Addendum # 2

Bid Opportunity: 25-7639-RFT - Alpine Public School HVAC Upgrade

RE: Alpine Public School – HVAC Upgrade
Kitchener, ON

ADDENDUM 01

OVERALL LIGHTING PLAN

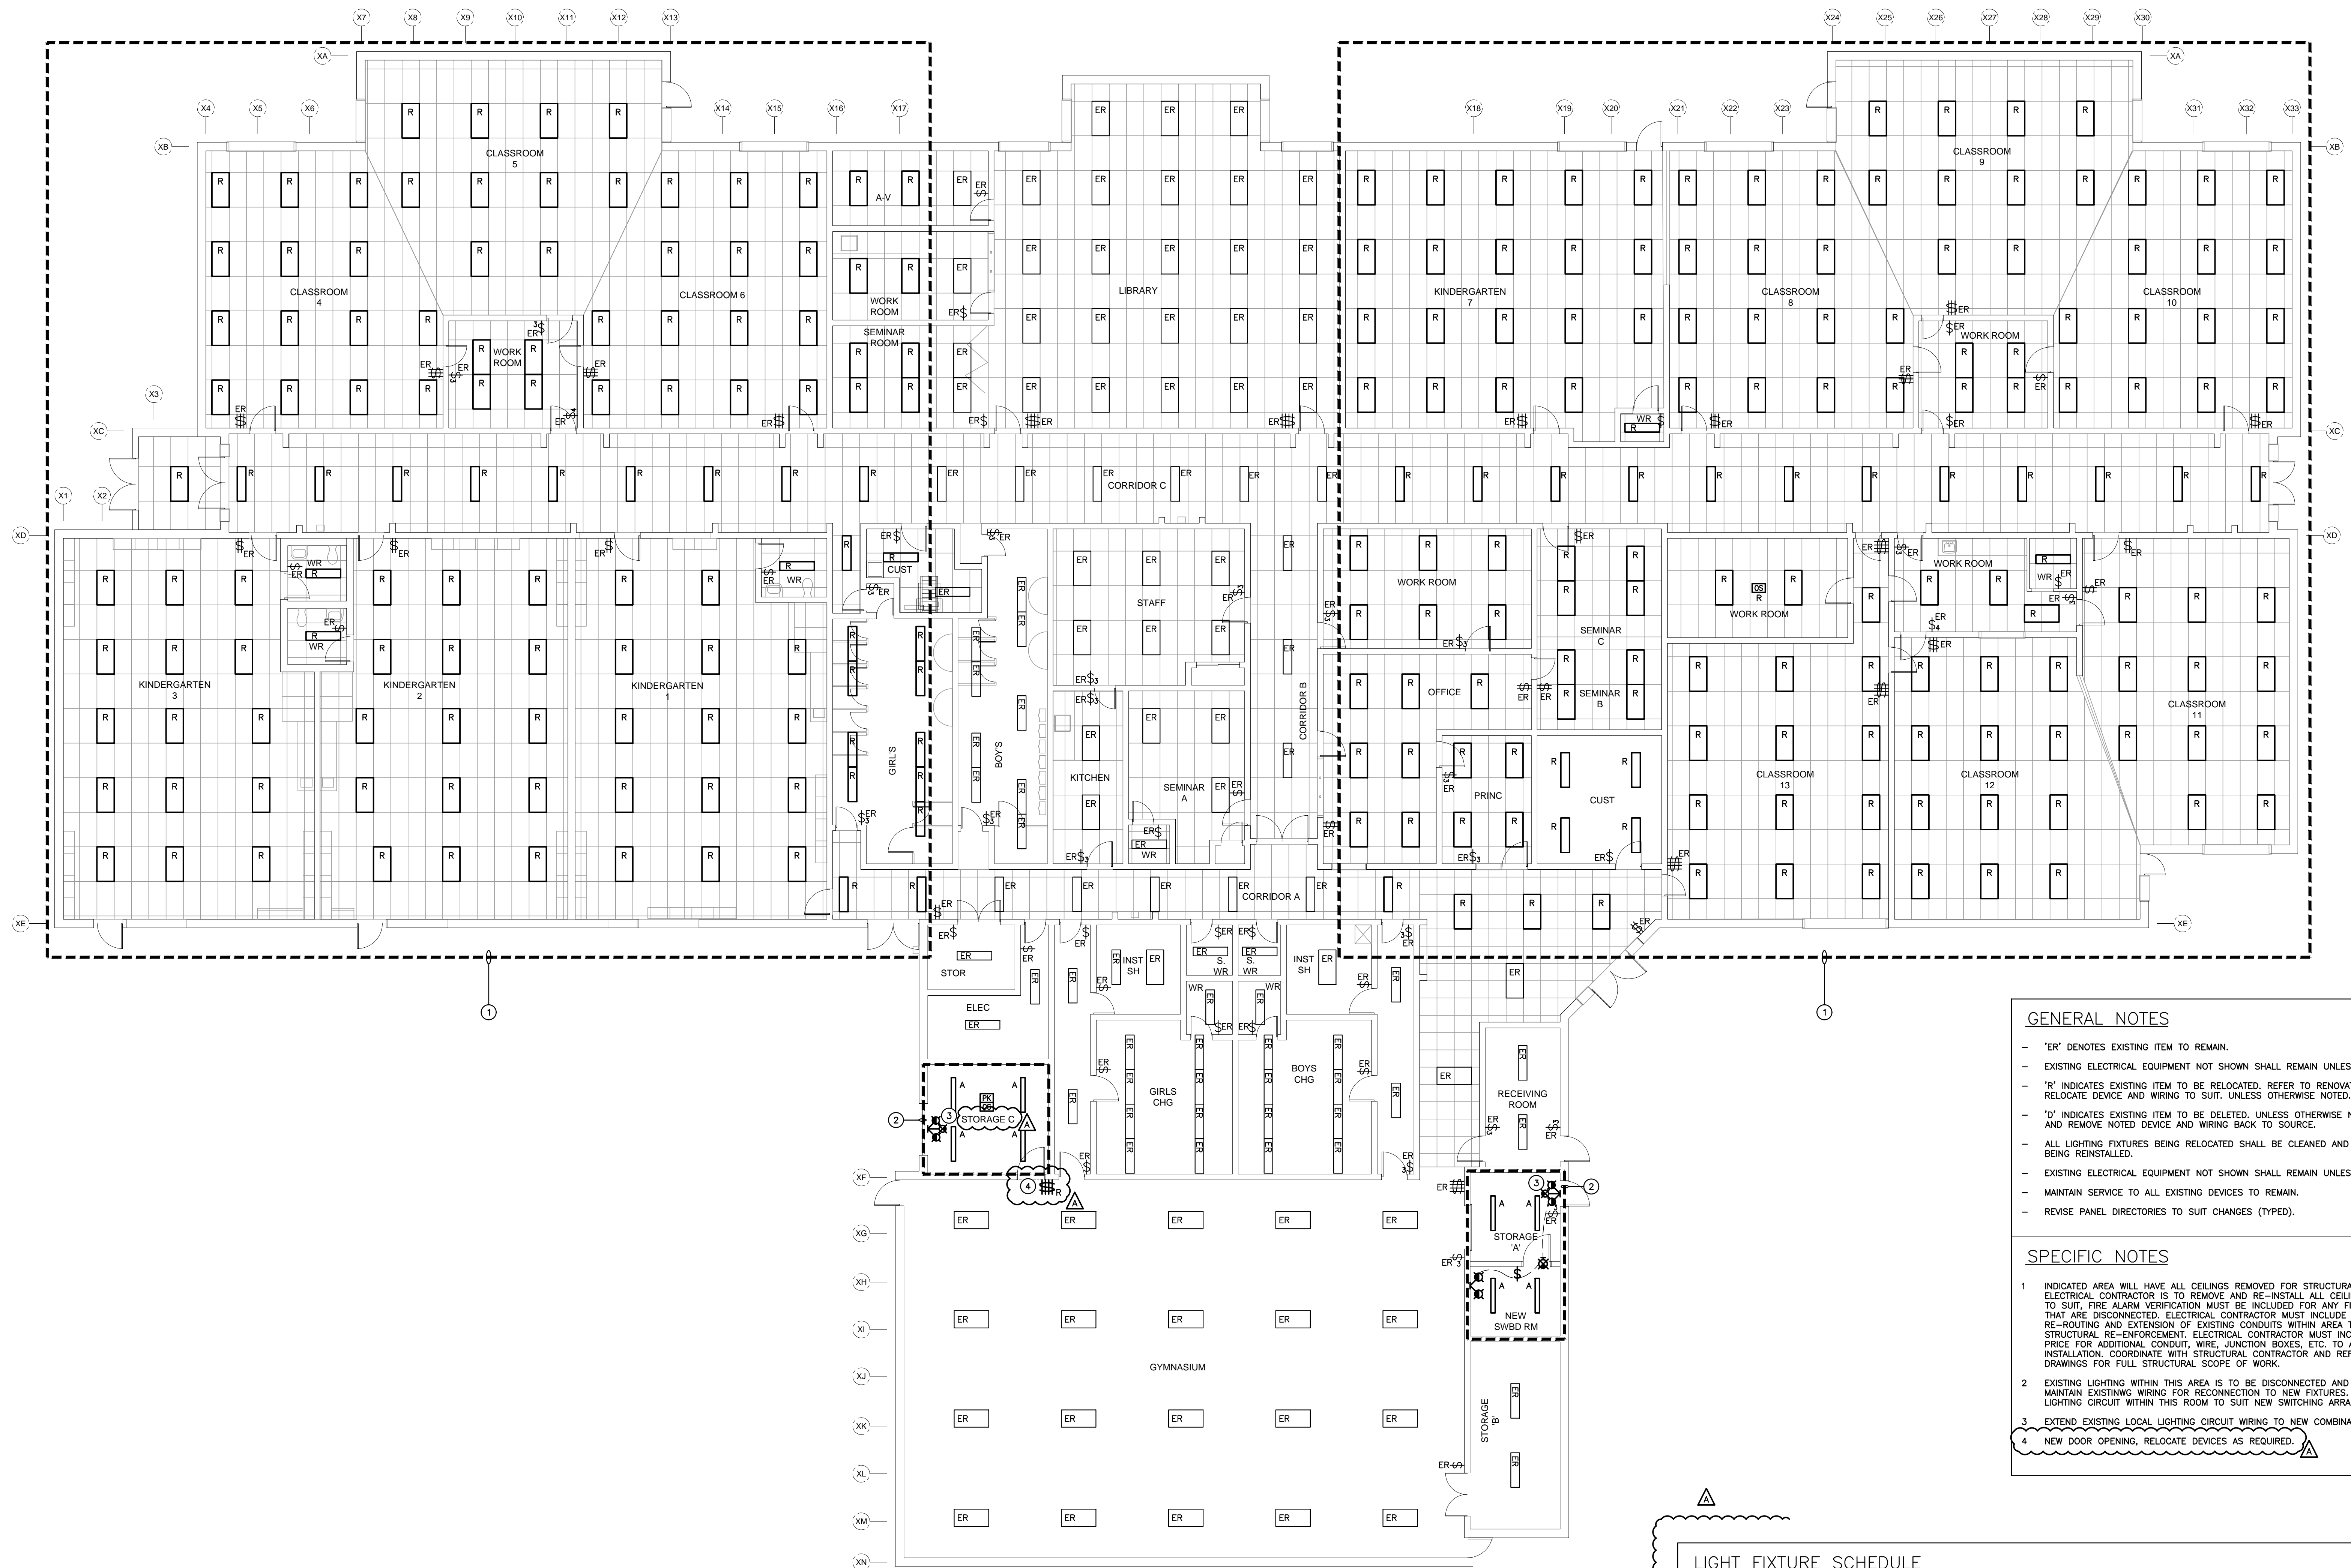
Item 3**3.0 Reference Attached Reissued Drawings E201 and E301**

- .1 Door within Storage C is to be replaced. Contractor to include for relocation of adjacent door devices to suit installation.
- .2 Contractor to remove and reinstall all devices along run of new conduit connecting the new and old switchboard.
- .3 Fixture schedule added.
